Re: Mine Unit 7 Monitoring Wells, Christensen Ranch In-Situ Operations, Permit No. 478

uraniumone	
Investing in our energy	
907 North Poplar St., Suite 200, Cheyenne, WY 82001 307-234-4238	
Christensen Ranch	
MU 7 Monitor Well Modifications	
Willow Creek	
Johnson & Campbell Counties, Wyoming	
Date: 11/03/2010	By: [Signature]
Drawn by: [Signature]	Checked by: [Signature]
Scale: [Signature]	Sheet: [Signature]

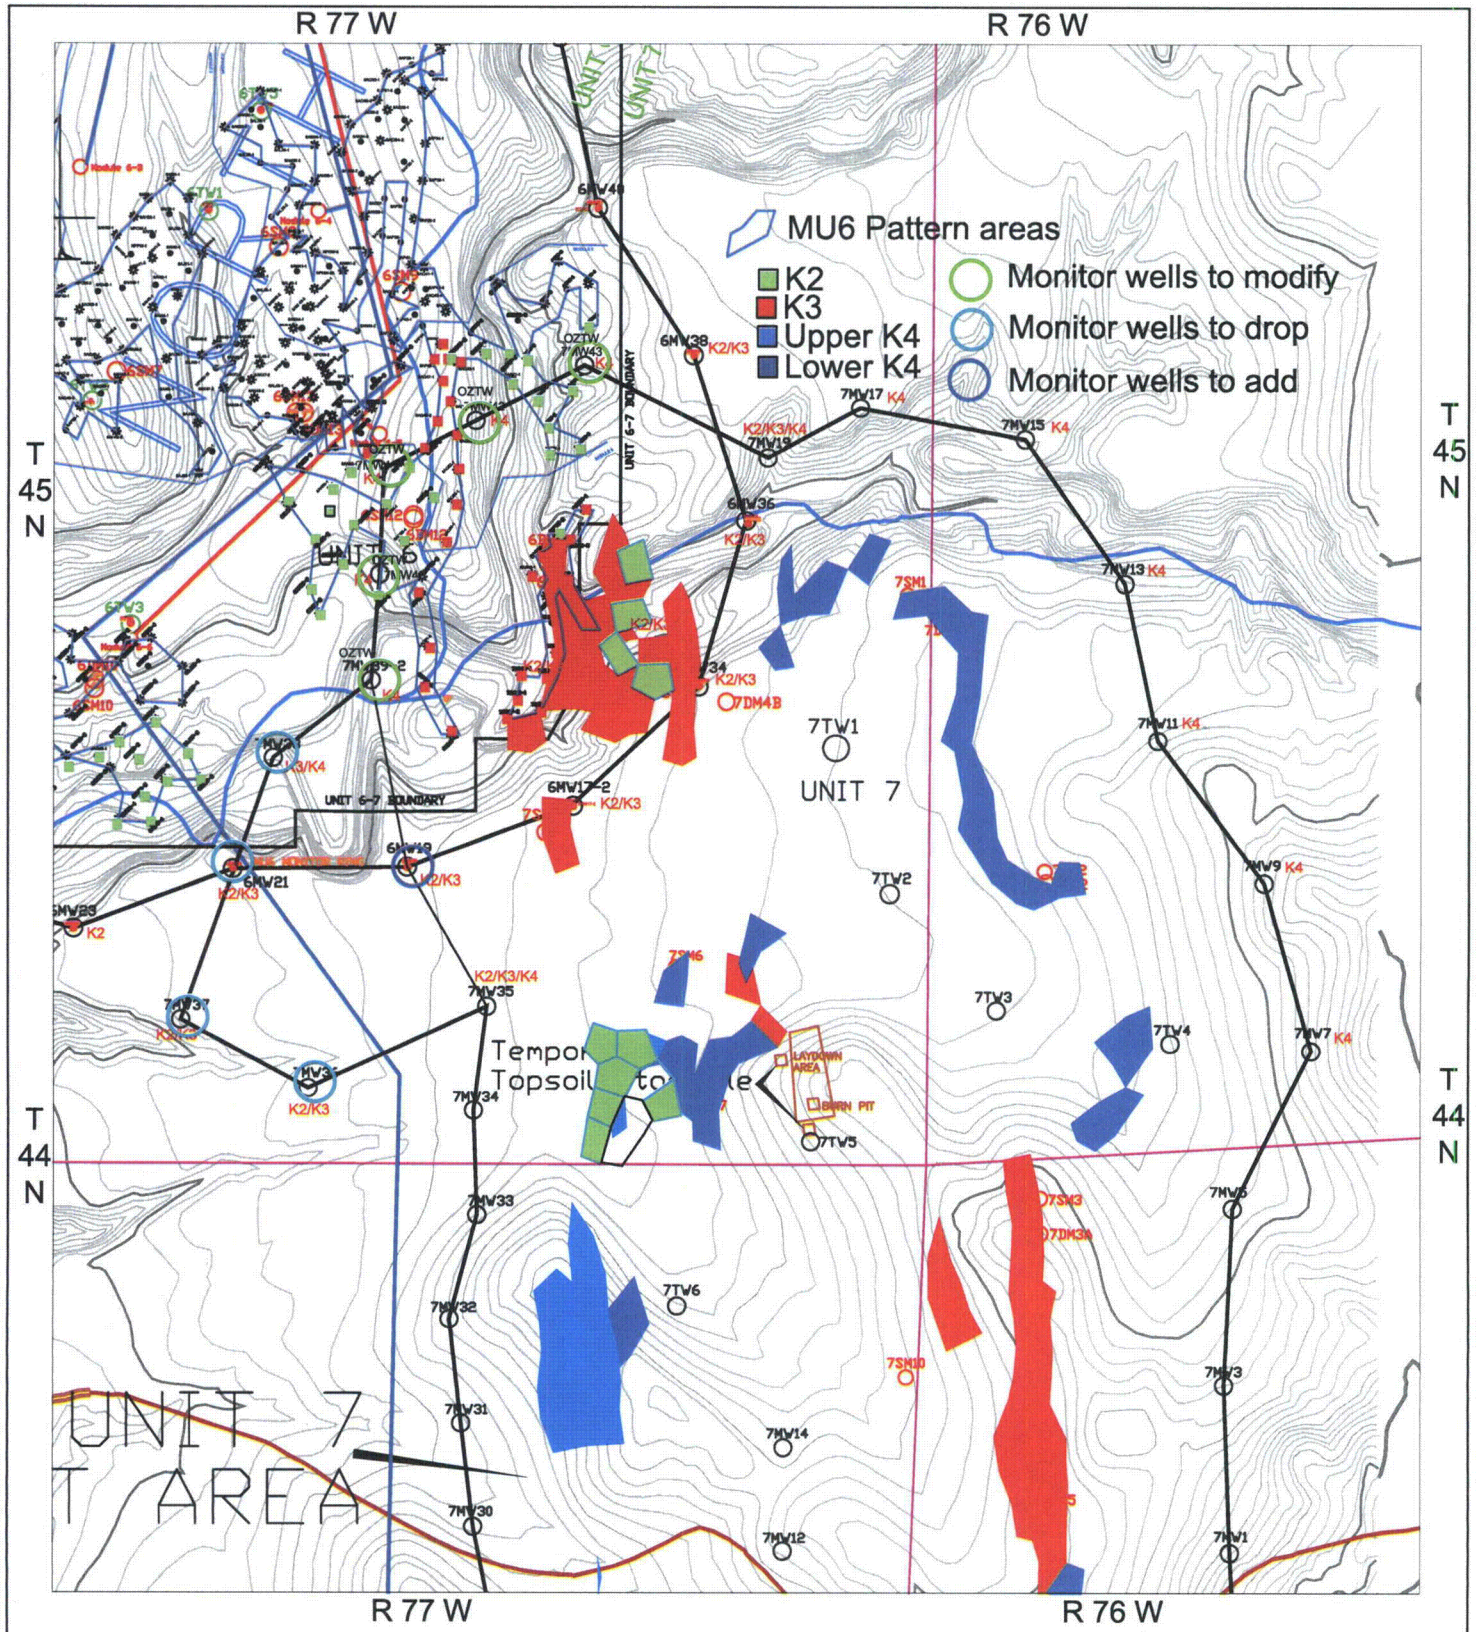
We also propose to eliminate four monitor wells (7MW36, 7MW37, 6MW21, and 7MW38) from the western lobe of the MU7 monitor ring, as they are too far away from the nearest mining patterns. We would like to use well 6MW19 as a replacement for these wells. 6MW19 is already completed in the appropriate sands (the K2 and K3 Sands). This well is located 380' west of the nearest mining pattern, which meets the monitor well spacing requirement outlined in the permit. It is located 445' from monitor ring well 7MW35, and 527' from monitor ring well 7MW39-2.

Completions projected from nearest mining patterns

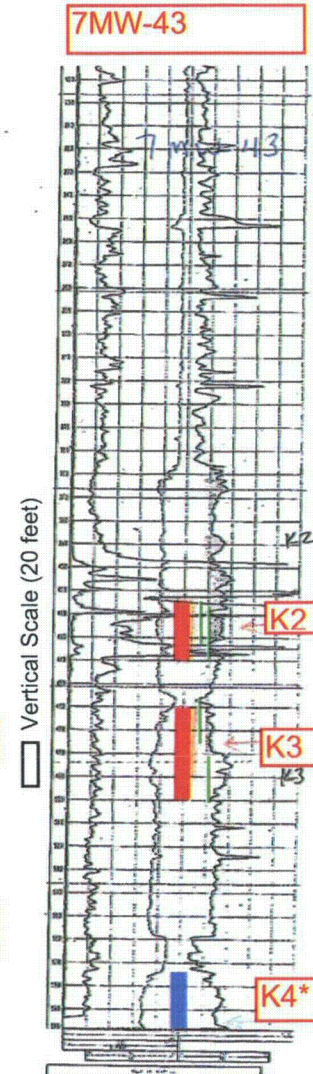
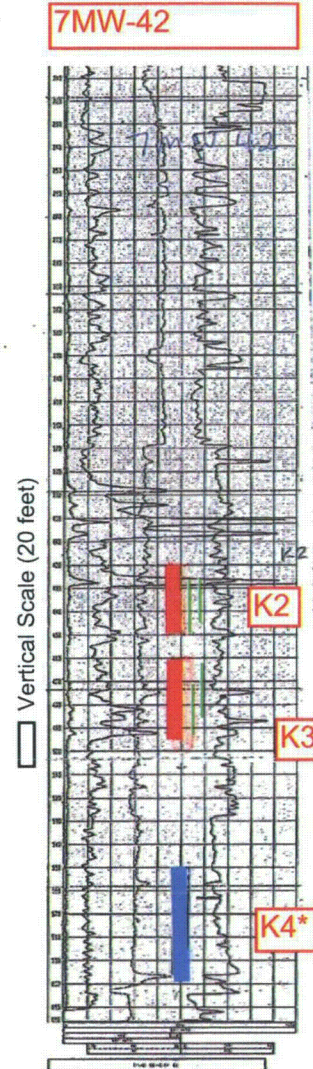
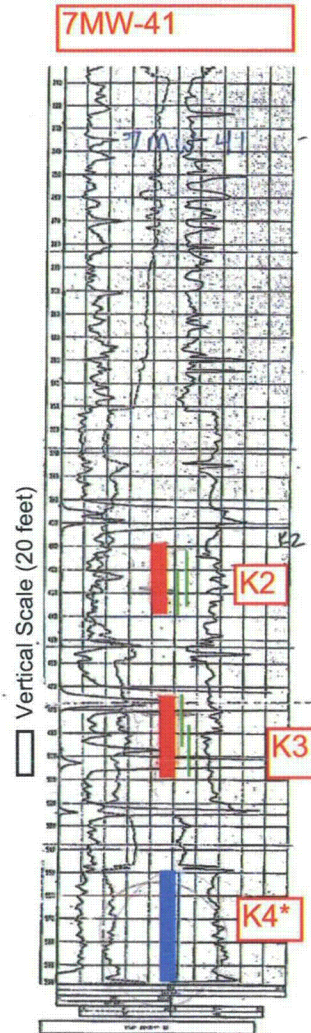
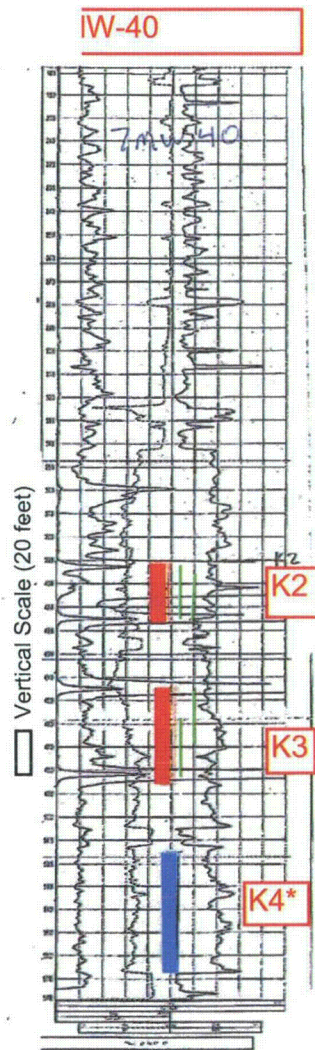
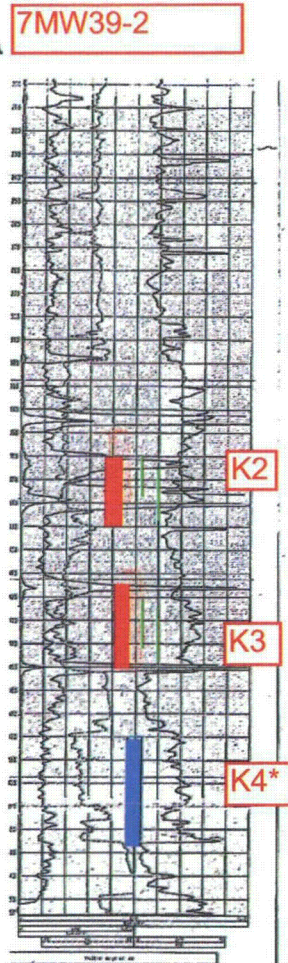
As discussed during your recent field inspection on October 20 and our meeting in Casper on October 28, the following information is presented to the WDEQ-LQD District III staff for consideration. As you know in the northwest portion of MU7, there are 5 monitor ring wells (7MW39-2, 7MW40, 7MW41, 7MW42, and 7MW43) that are completed in the K4 Sand. The patterns nearest these monitor wells will target K2 and K3 mineralization. In order to monitor the appropriate sands, it is proposed that we complete each well higher in the K Sand where mining will take place. In these cases we also propose to seal off the K4 Sand interval. Since these wells fall within an area that was previously mined (Module 66), we plan to recompleteness them in the K2 & K3 Sands and reclassify them as ore zone trend wells.

For example, well 7MW39-2 is completed from 480' to 525' in the K4 Sand. Two smaller individual windows will be cut (360' to 390' in the K2 Sand, and 415' to 450' in the K3 Sand). Similar scenarios are proposed for the other four monitor ring wells listed above (see attached cross section).
